Design Review Commission Report

Meeting Date: Thursday, December 4, 2014
(continued from November 6, 2014)

Subject: **208 South Stanley Drive (PL1429432)**
A request for an R-1 Design Review Permit to allow for construction of a new two-story single-family residence located in the Central Area of the City south of Santa Monica Boulevard. The Commission will also consider adoption of a Categorical Exemption, pursuant to the California Environmental Quality Act.

Corrections from November 6th, 2014 Design Review Commission Meeting

Applicant's Written Response to Commissioner's Comments

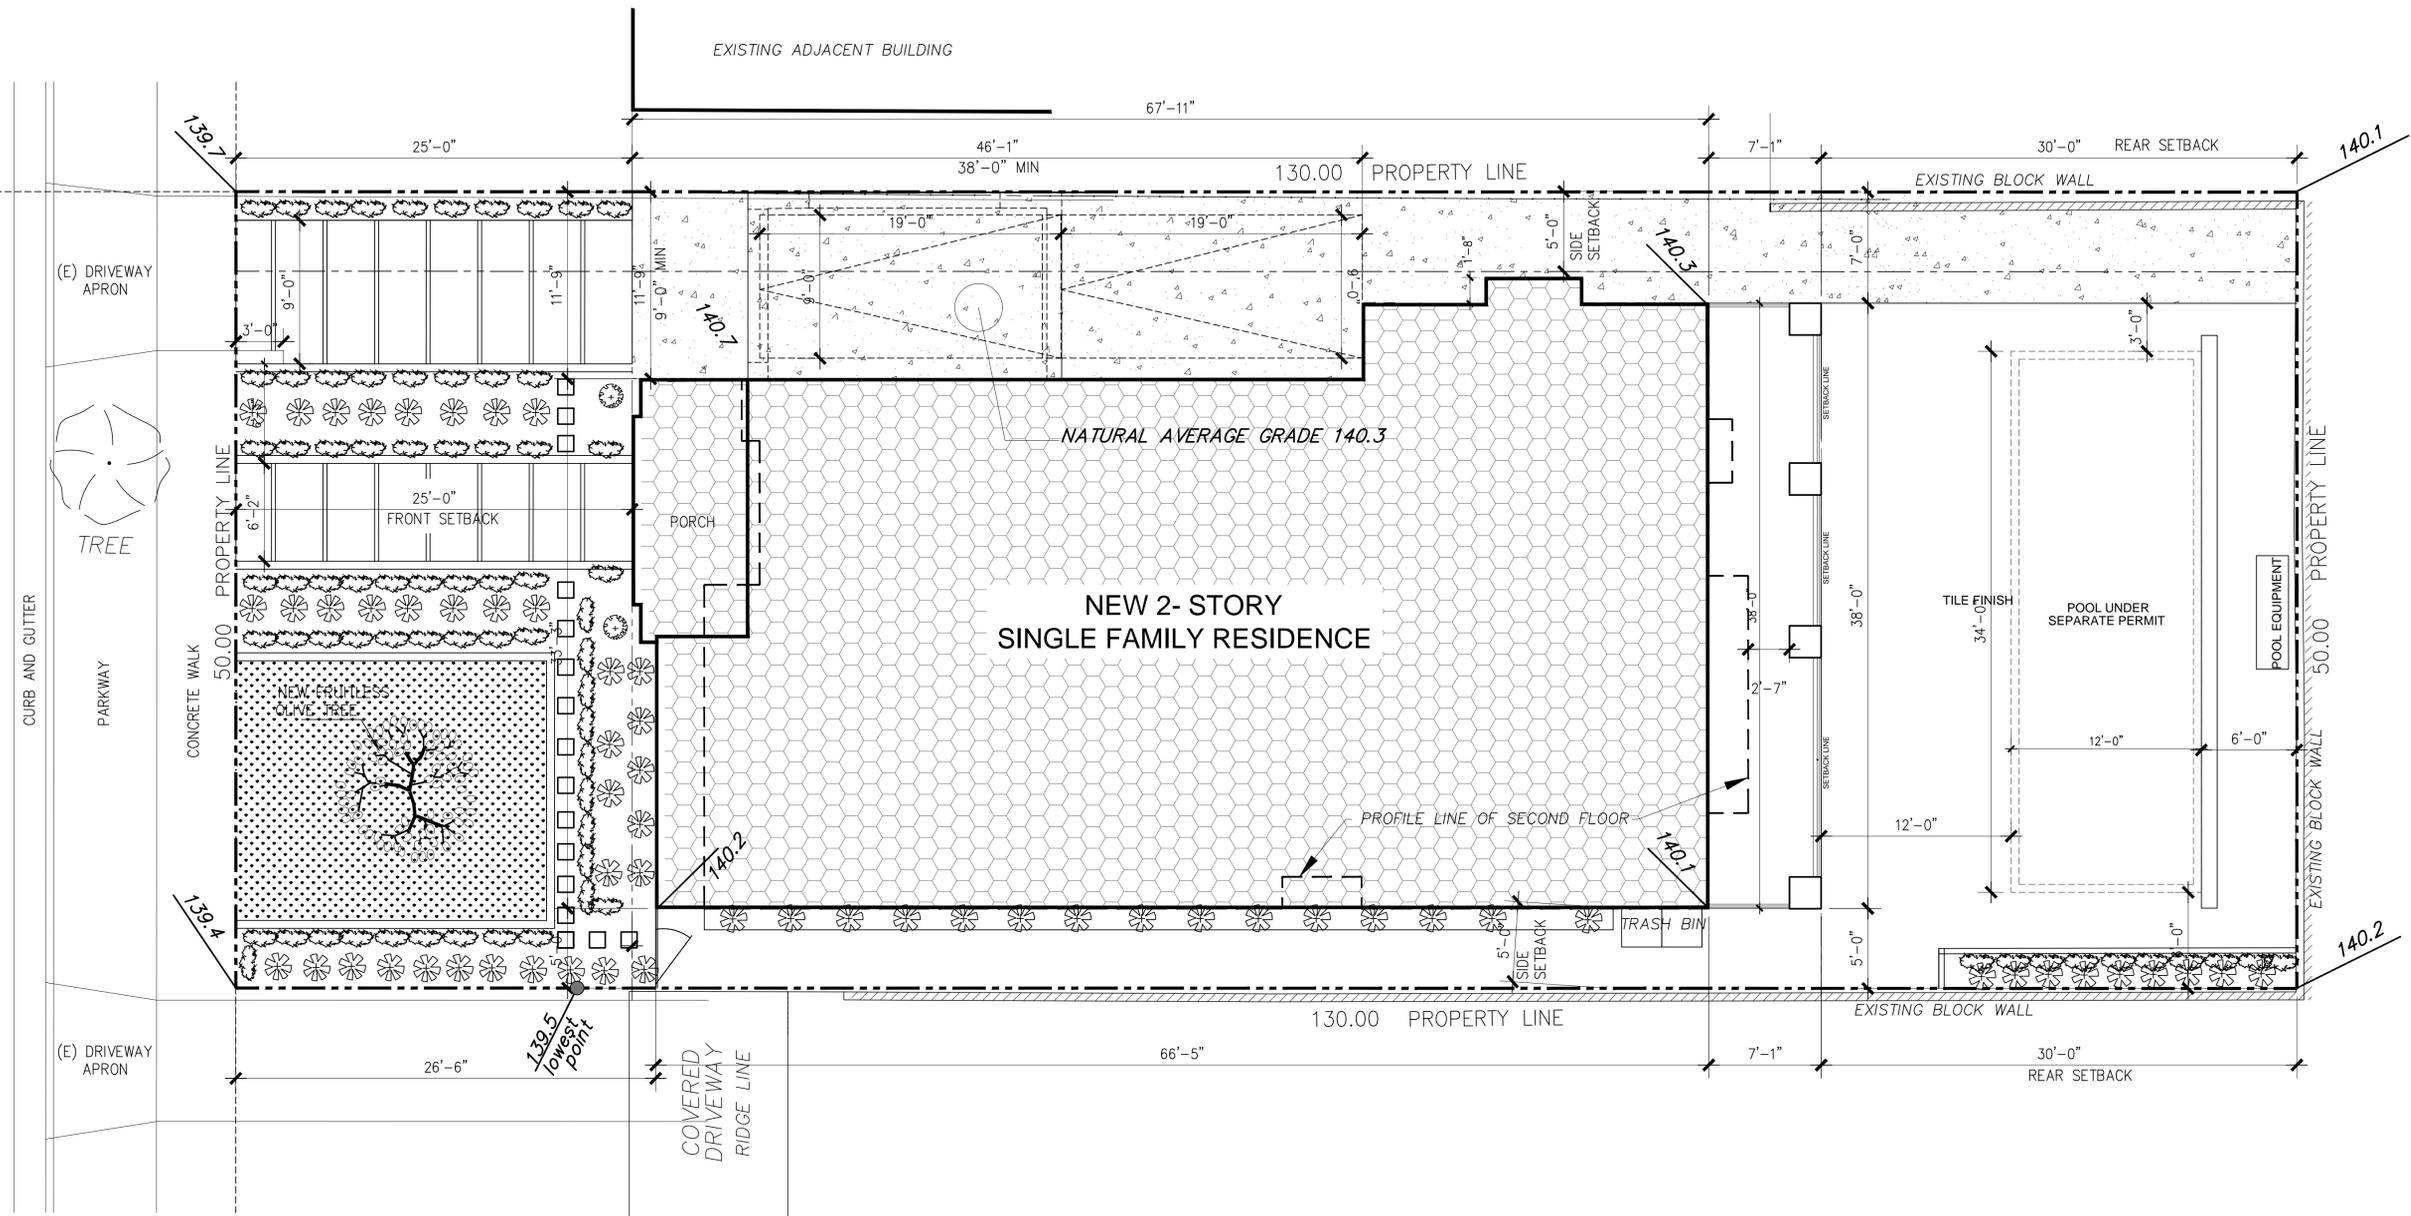
Based on a review conducted by the Urban Design Team, the façade entry element appears a bit heavy and lopsided creating an imbalance to the façade. The heavy columns on the upper portion compete and create too much weight on the entry below. In addition, the arched windows on the side elevation compete with the front door. The landscape design for the front yard does work well with the overall design. Staff has not included project-specific conditions of approval related to these comments but the Commission may wish to consider these comments during their review and analysis of the project.

SHEET NO.:
A-3.0

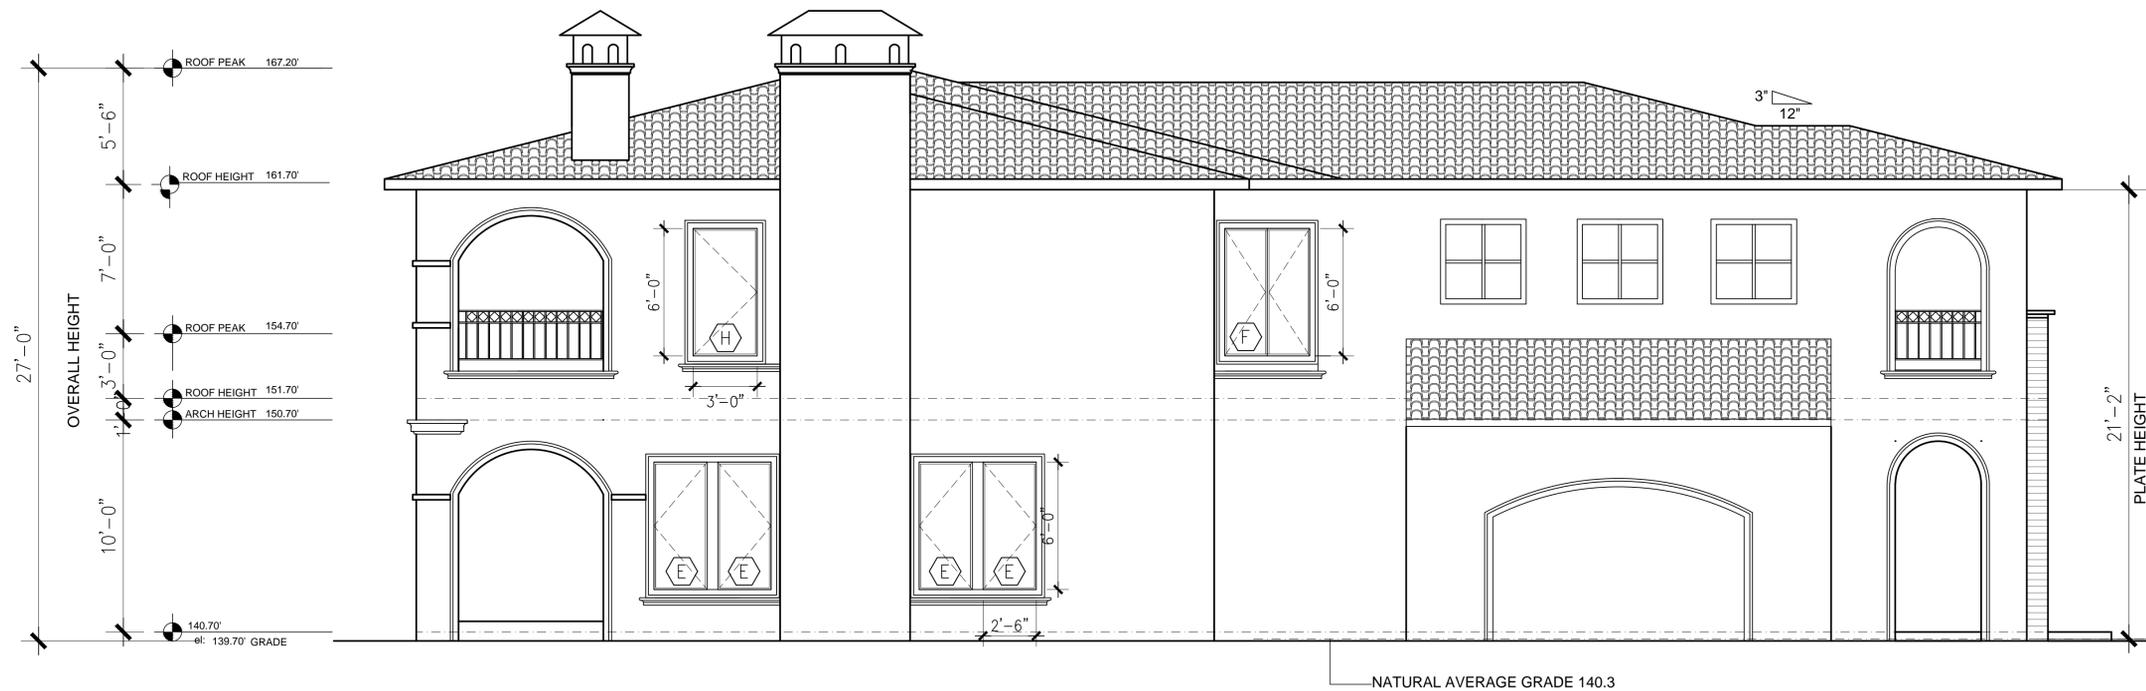
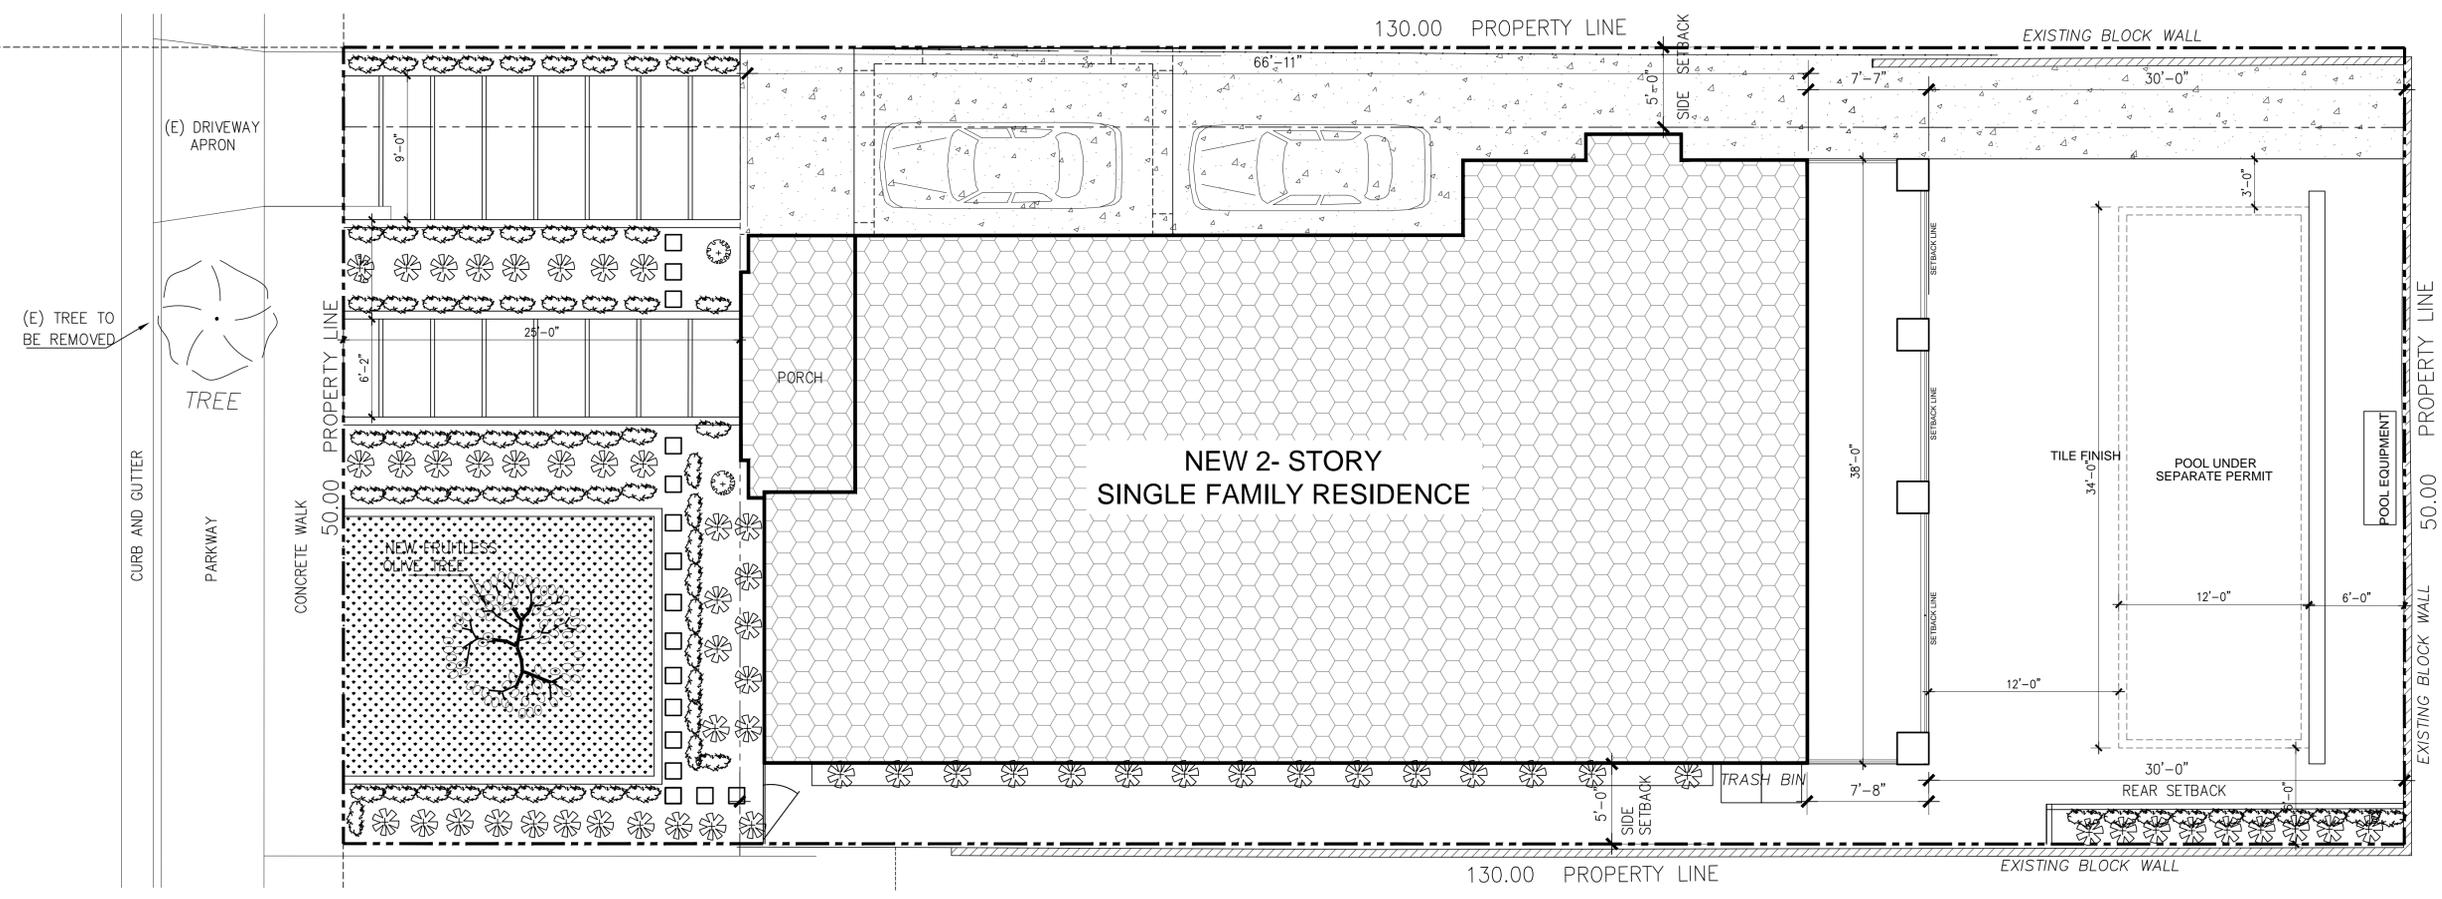
- 3) Make the front of the house less heavy and bulky
 - a. Made the side columns thinner, less bulky
- 4) Show gutters on the rendering
 - a. Rendering shows the gutters and also shown on the plans page A-3.0

- a. Updated the plans to reflect these changes by removing the wrought iron railing and building a balcony wall of 42" high
- 7) Continue the front limestone to the top of the new 42" balcony wall above the front door

- a. Limestone on the front is continued to the top of the balcony wall on the rendering and plan page A-3.0
- 8) Remove the wrought iron railings from the first floor window to the right of the front entry door

- a. Removed the wrought iron railing from the front of the lower front window on page A-3.0
- 9) Raise the window to the right of the front door about 18" from the slab

- a. Raised the window 18" above the ground on page A-3.0
- 10) Roof rendering to be closer in color to the actual tile being used
 - a. New rendering reflects this change
